14 November 2024

RE: HIA Feedback on Draft Queensland Housing Code

Rear Allotment Diagram (Current)

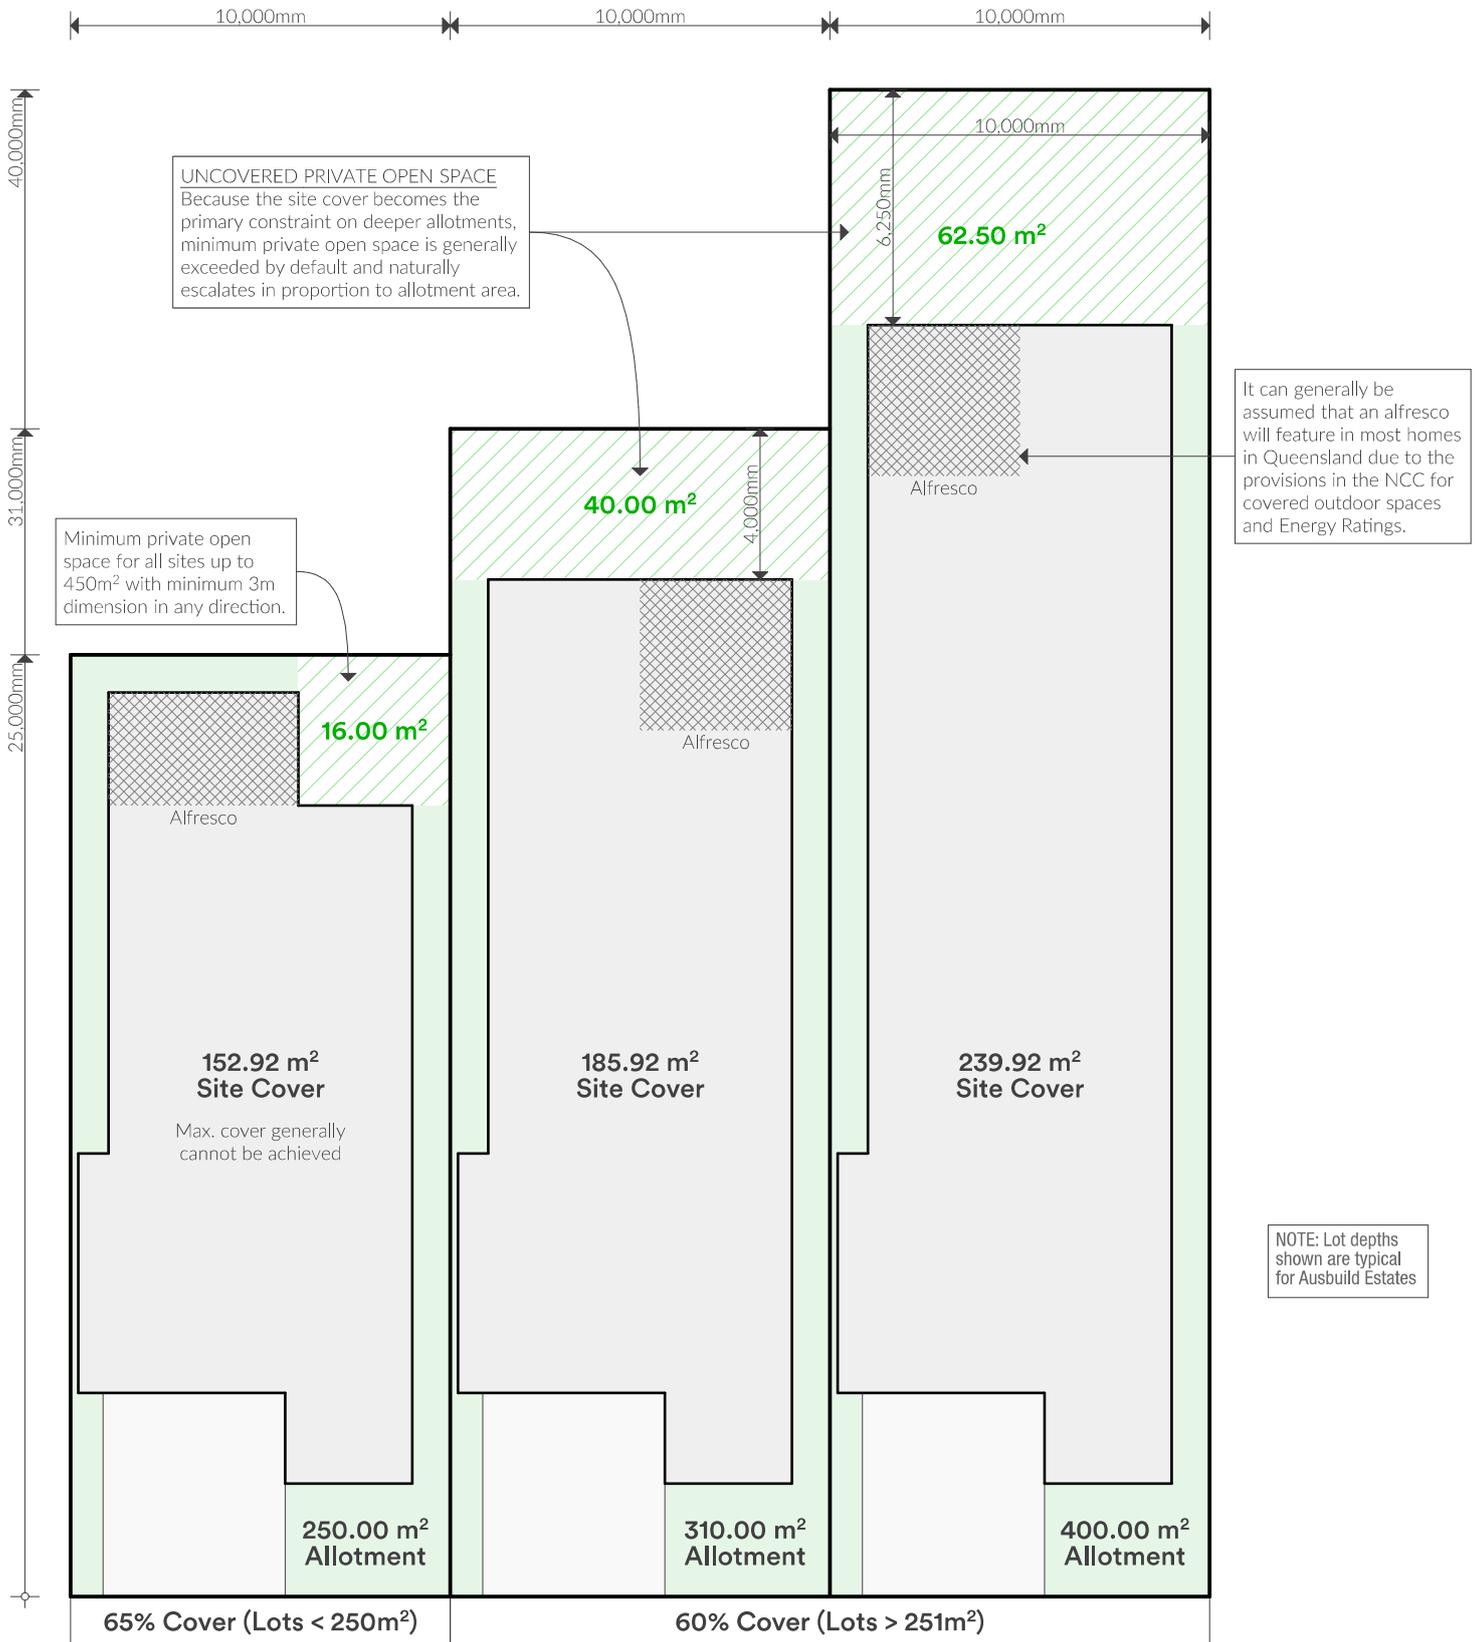
The site plans above illustrates that applying the proposed dwelling setbacks and the site cover requirements are often restricting one or the other and this needs further work for it to be useful.

REAR SETBACK ALTERNATIVE SOLUTION

Lower Level Rear Setback Diagram

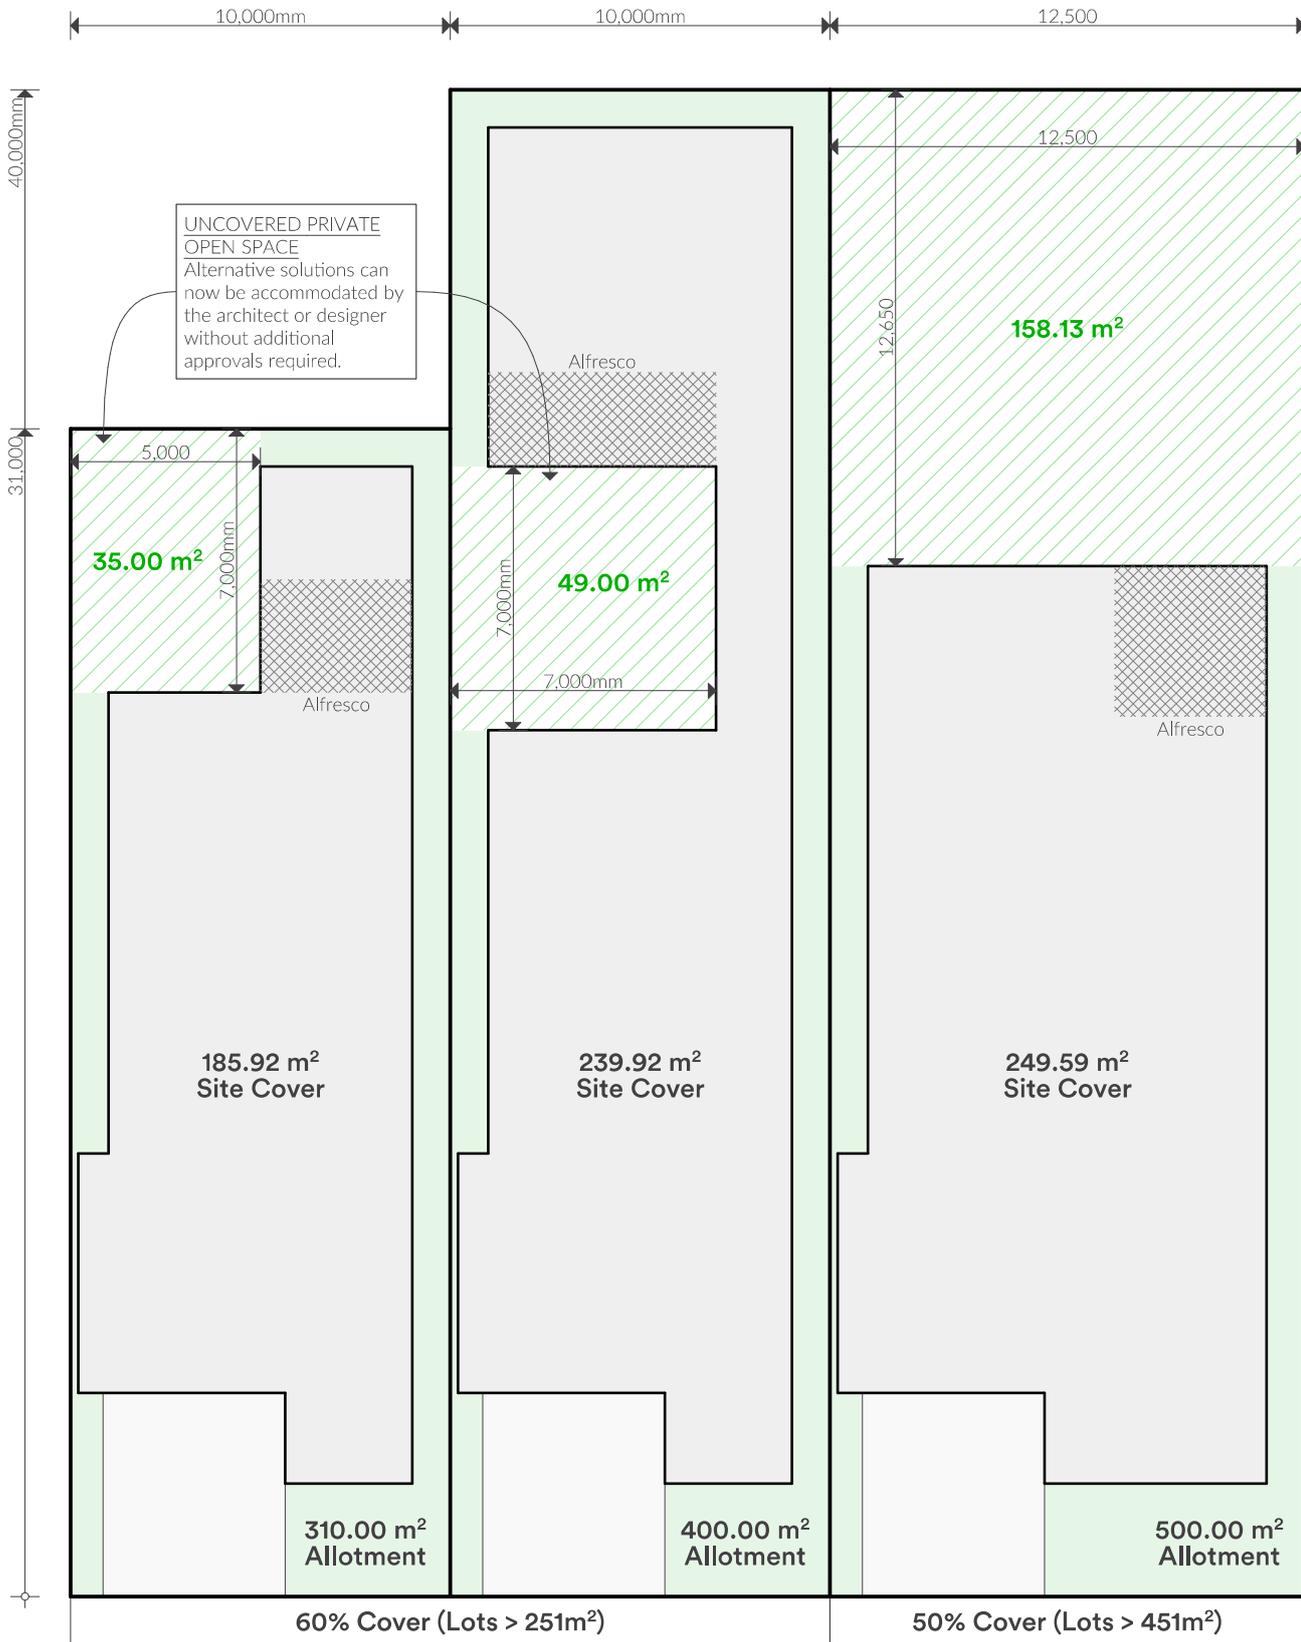
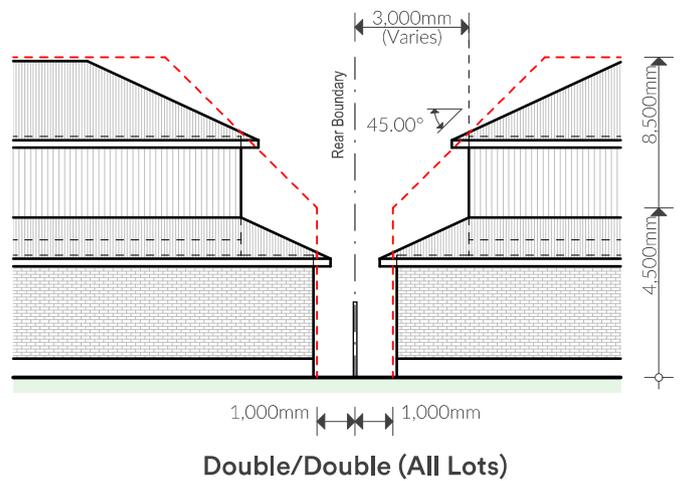
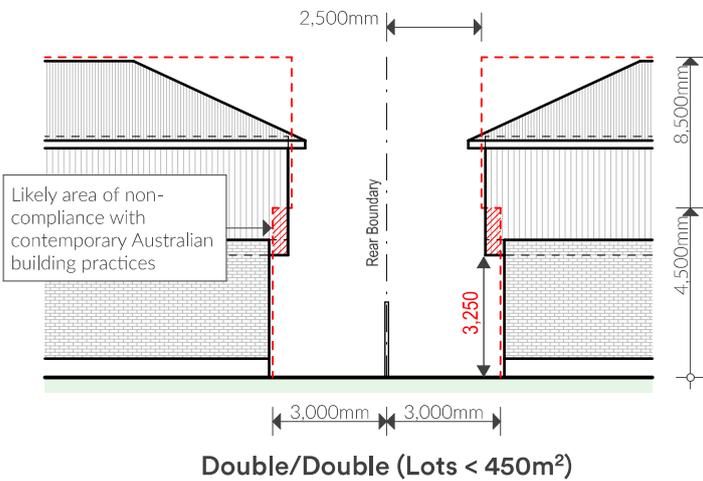
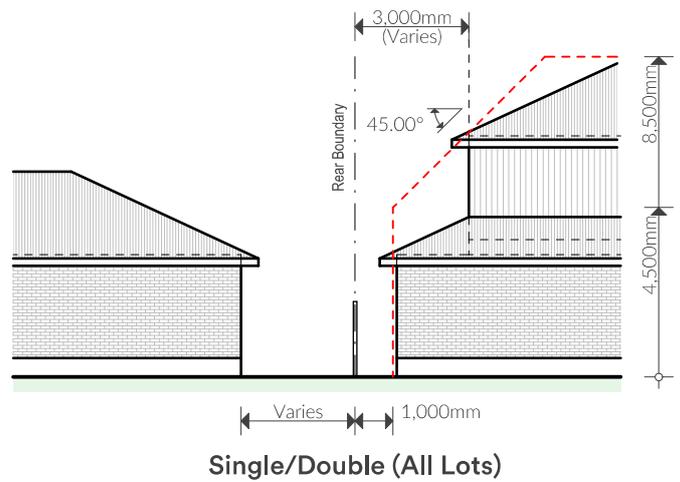
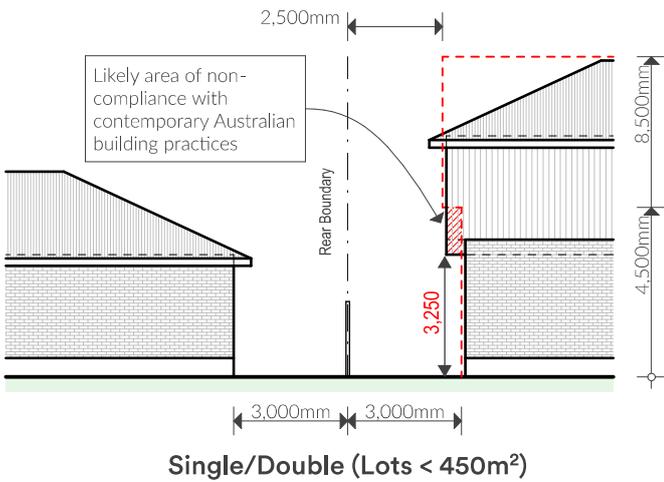
The diagrams below illustrate that the proposed QHC rear setback need to be properly described for the building industry and avoid interpretation problems resulting in delays. Using building setbacks that are cognisant of the sunlight to neighbouring properties are logical and will generally assist the privacy screening requirements.

REAR SETBACK ALTERNATIVE SOLUTION

Rear Alfresco Setbacks
CURRENT PROPOSAL

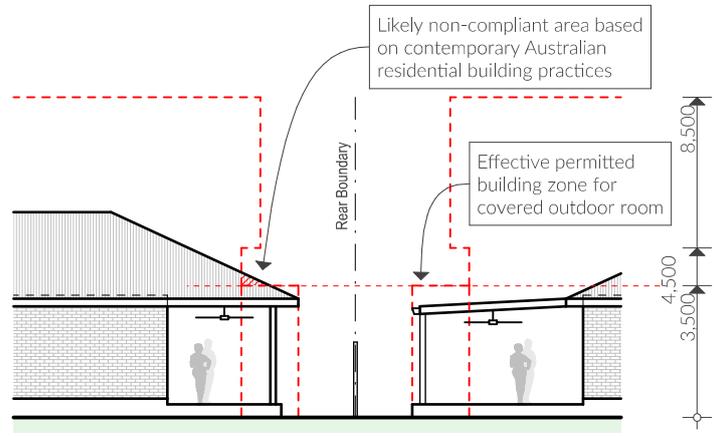
The diagram below shows why this is difficult to achieve an outdoor room less than 3.5m in height using typical building materials & methods. The low pitch insulated roof will have limitations for the installation of a ceiling fan and achieve the thermal download requirements. This potentially, means that the QLD energy efficiency credits for the outdoor living space may not be achievable.
